## Draft Supplement 1 to Regulation No. 127 in its original version

### I. Proposal

**Figure 8A**

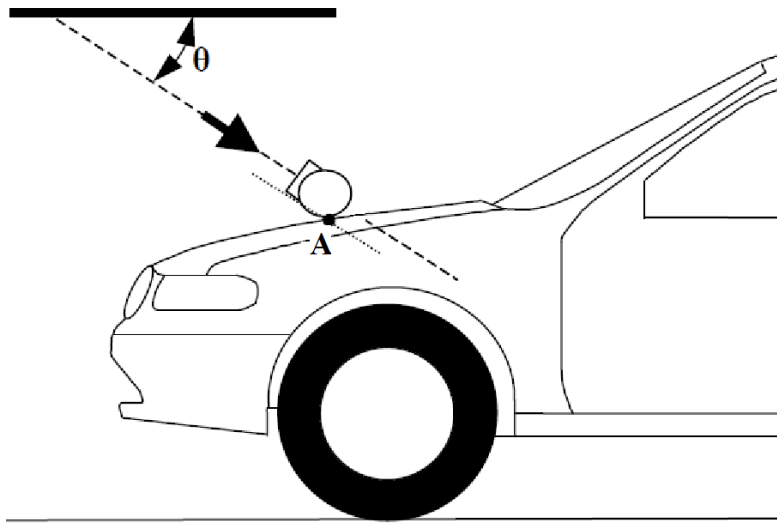
Insert new paragraphs 2.26. to 2.26.2. and new figures 8A and 8B, to read:

2.26.1. "Measuring point" for the headform test means a point on the vehicle's outer surface selected for assessment. The measuring point is where the headform's profile contacts the vehicle's outer surface cross section in a vertical longitudinal plane through the center of gravity of the headform (see Figure 8A).

Measuring point in the vertical longitudinal plane through the center of the headform impactor (see paragraph 2.26.1.)<sup>2</sup>

**Figure 8B**

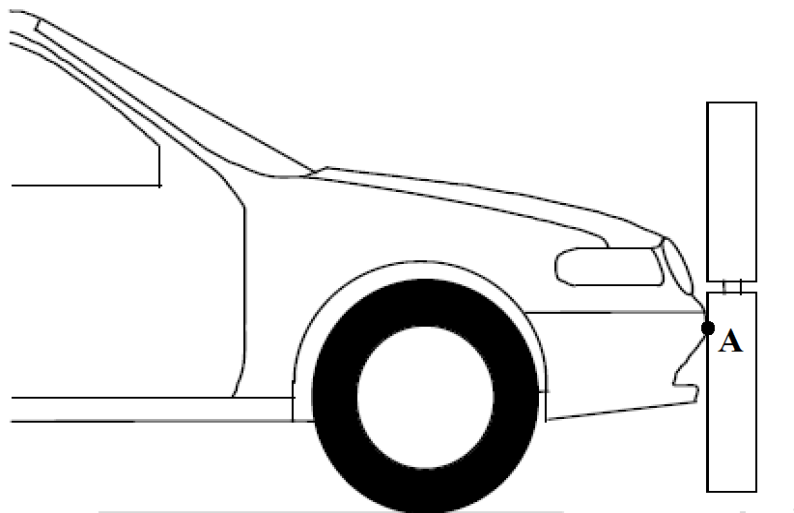
2.26.2. "Measuring point" for the lower legform to bumper test and the upper legform to bumper test is located in the vertical longitudinal plane through the central axis of the impactor (see Figure 8B).

**Measuring point in the vertical longitudinal plane through the central axis of the legform impactor (see paragraph 2.26.2.)**

"Figure 3

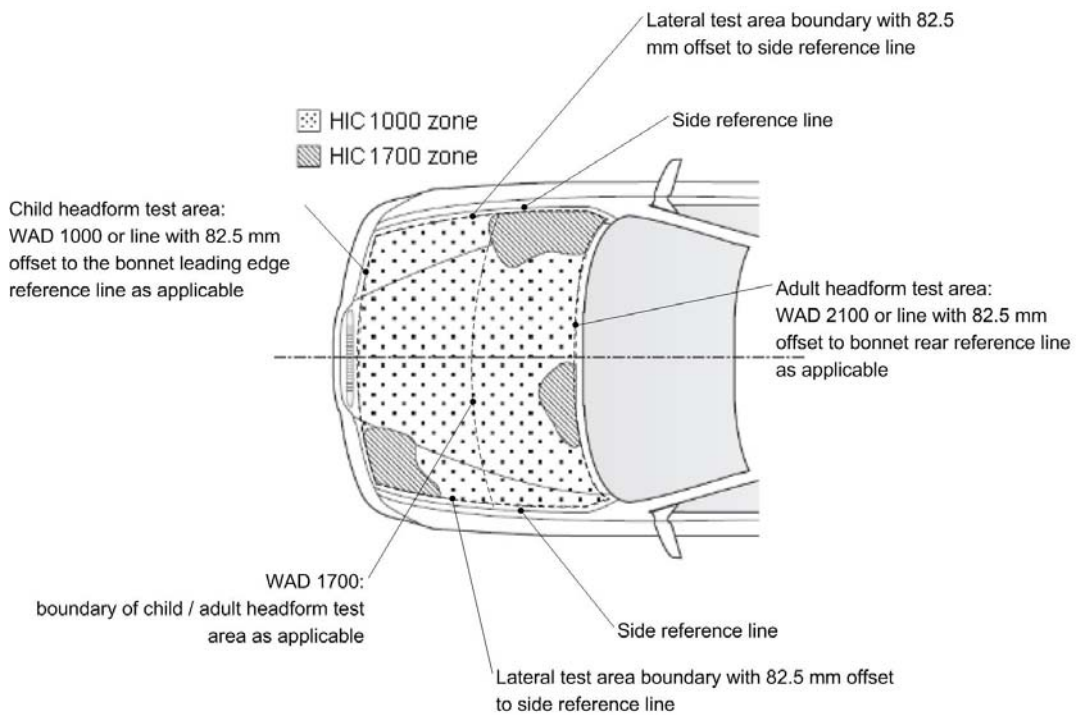
"3.4.1. The manufacturer shall identify the zones of the bonnet top **test area** where the HIC must not exceed 1,000 (HIC1000 Zone) or 1,700 (HIC1700 Zone) (see Figure 3)."

*Annex 5, Figure 3*, amend to read:

**Example of marking of HIC1000 zone and HIC1700 zone**
